UNITED STATES PATENT AND TRADEMARK OFFICE

APPLICATION NO.	FILING DATE	FIRST NAMED INVENTOR	ATTORNEY DOCKET NO.	CONFIRMATION NO.
10/616,090	07/08/2003	Douglas M. Baney	10020766-1	9657

Office Action Summary

DETAILED ACTION

Fig. 1

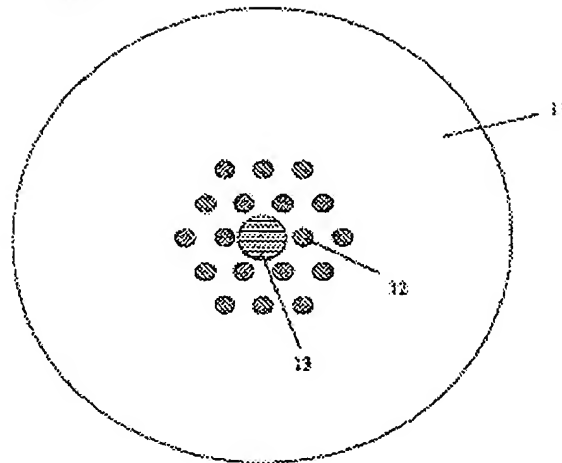
Claim 4: The holey waveguide comprises a core (11); and a plurality of voids formed in said core (12) (See for example Fig. 1).

Fig. 9

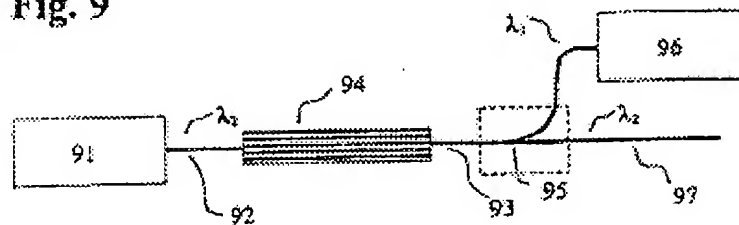
Claim 1: Bjarklev discloses in Figs. 1, 2, 4, 5, and 9 an optical waveguide absorption cell (Fig. 9), comprising: a first wave-guide ((92); a holey waveguide (94) filled with a known selective absorption medium (col. 5, lines 30-36), wherein a first terminus of said holey

waveguide (94) is coupled to a first terminus of said first waveguide; and a second waveguide (93), wherein a first terminus of said second waveguide is coupled to a second terminus of said holey waveguide.

However Bjarklev does not explicitly disclose the first terminus of said holey waveguide is coupled to the first terminus of the first waveguide utilizing a fusion splice (claim 2) or a light-transmitting adhesive (claim 3).

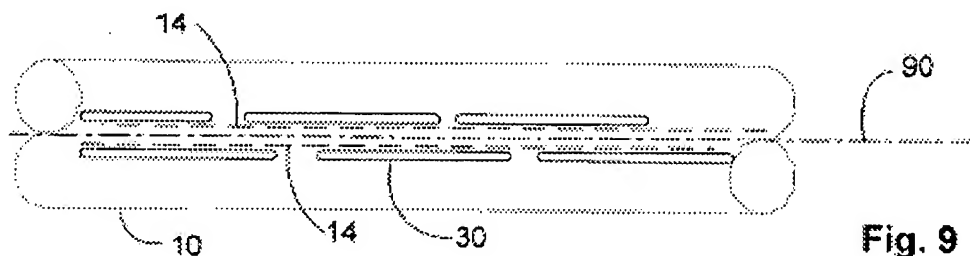
However, Bjarklev does not disclose the holey waveguide further comprises a fill hole formed in the core, wherein the fill hole is an opening in the core that is not at the first terminus of the holey waveguide and is not at the second terminus of the holey waveguide, the fill hole adapted to introduce the known selective absorption medium into the plurality of voids.

Levenson discloses the method of filling the holey waveguide with the known selective absorption medium through capillary action from the holes in the cladding (Fig. 9 and col. 4, lines 1-6) for the purpose of controlling the refractive index of the waveguide.
